**PEA RIDGE PUBLIC SERVICE DISTRICT
CABELL COUNTY, WEST VIRGINIA**

CONTRACT #4 – ROUTE 2 SOUTH SANITARY SEWER EXTENSION

ADDENDUM #2

JULY 24, 2023

SHEET No.
DET-6

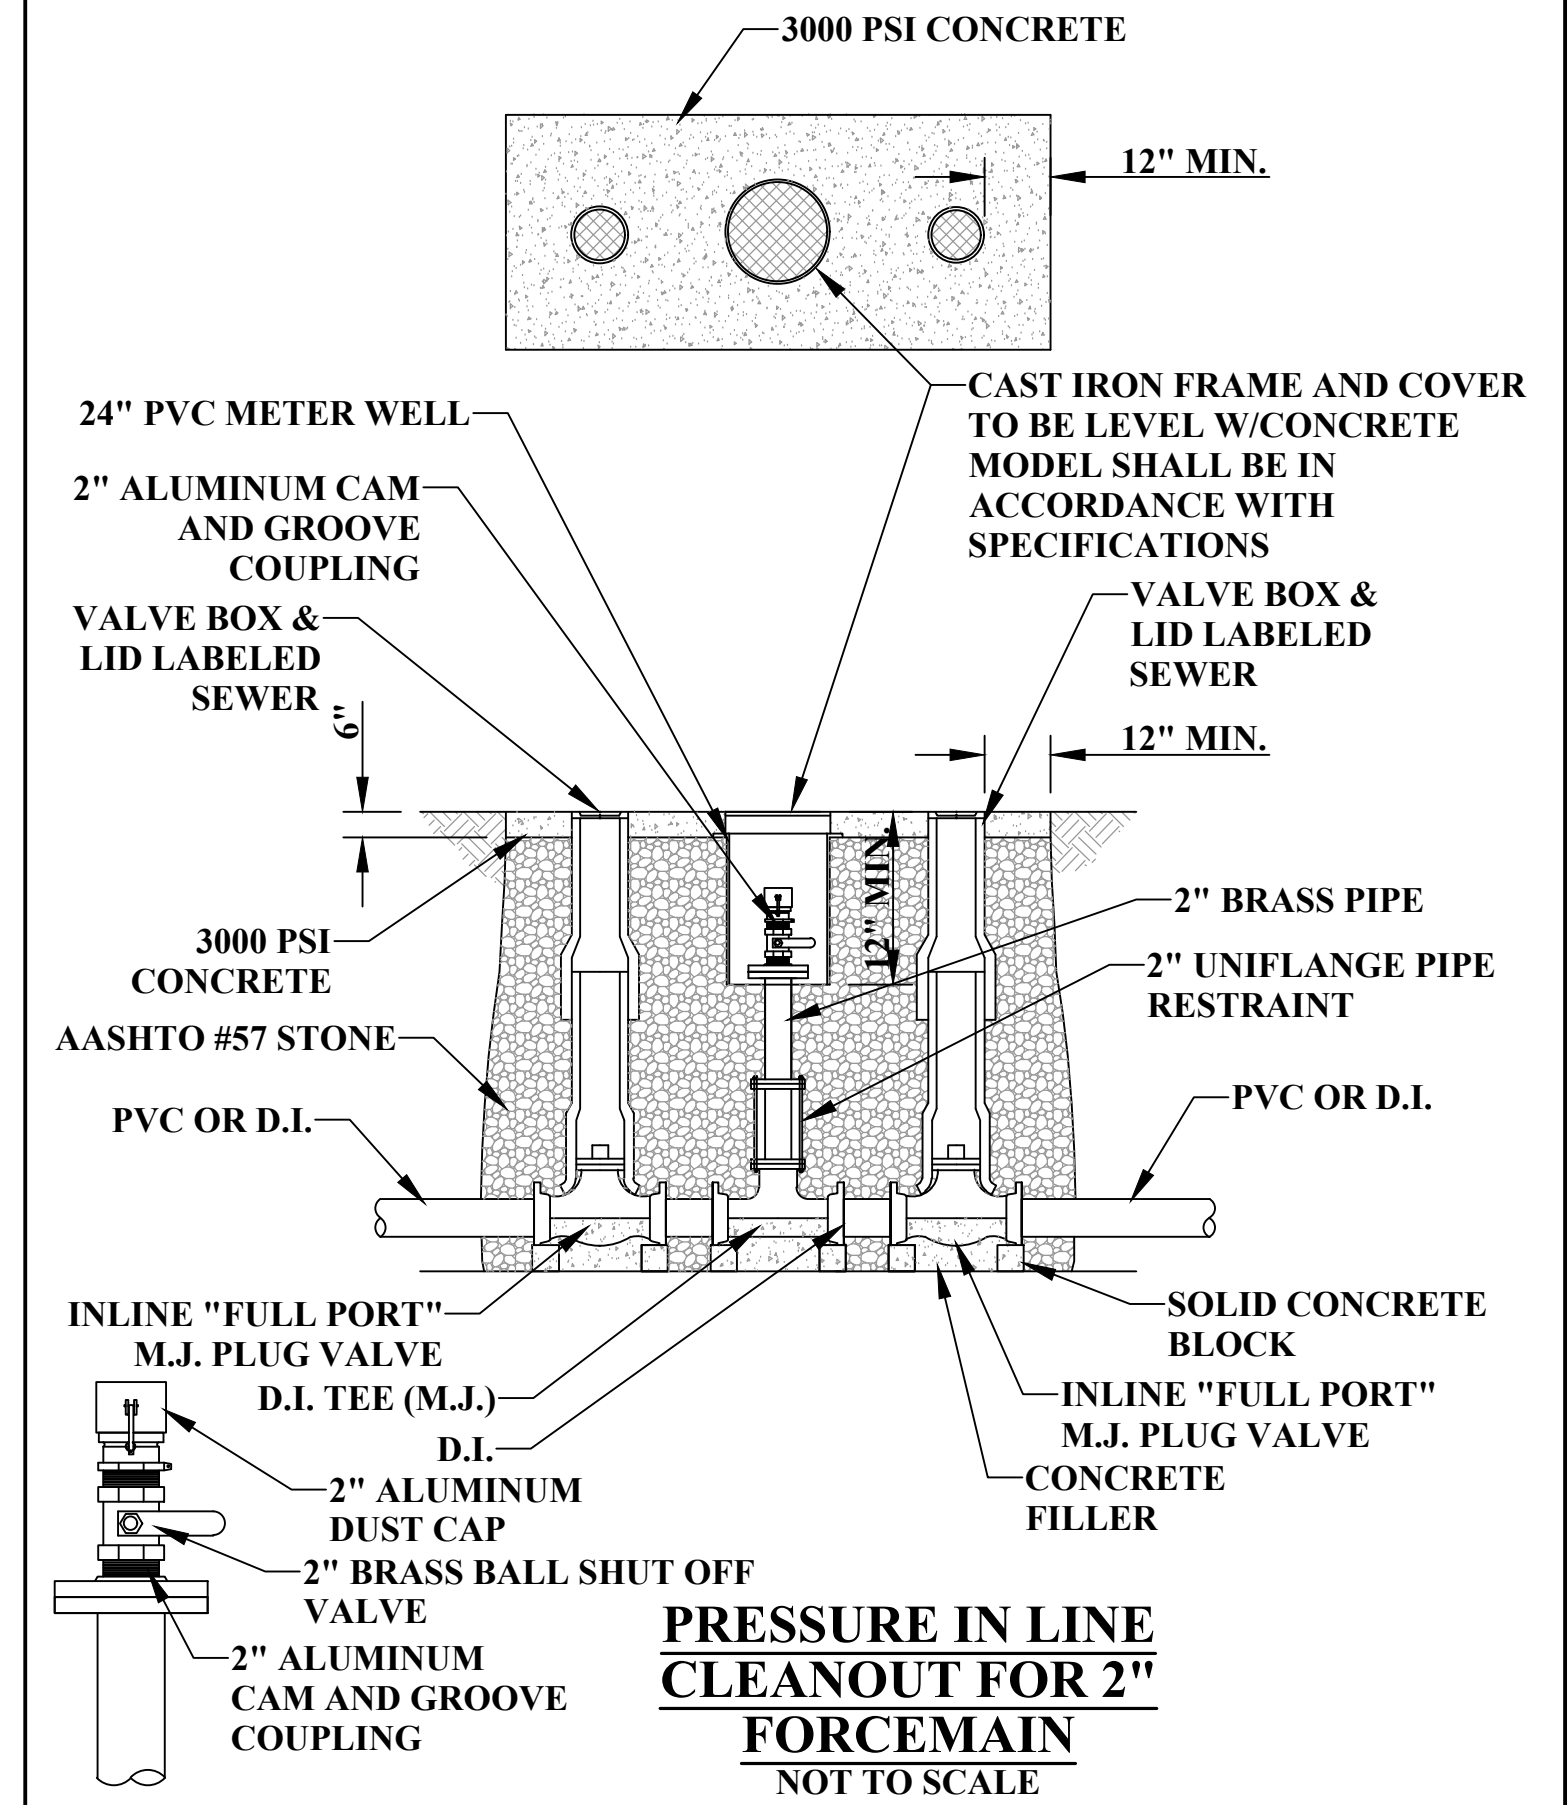
Will you add a bid item and detail for the 2" inline cleanout found on page 16 of the contract drawings?

Bid item 20b has been added for the 2" inline cleanout. The detail is located on sheet DET-6 included with this Addendum #2.
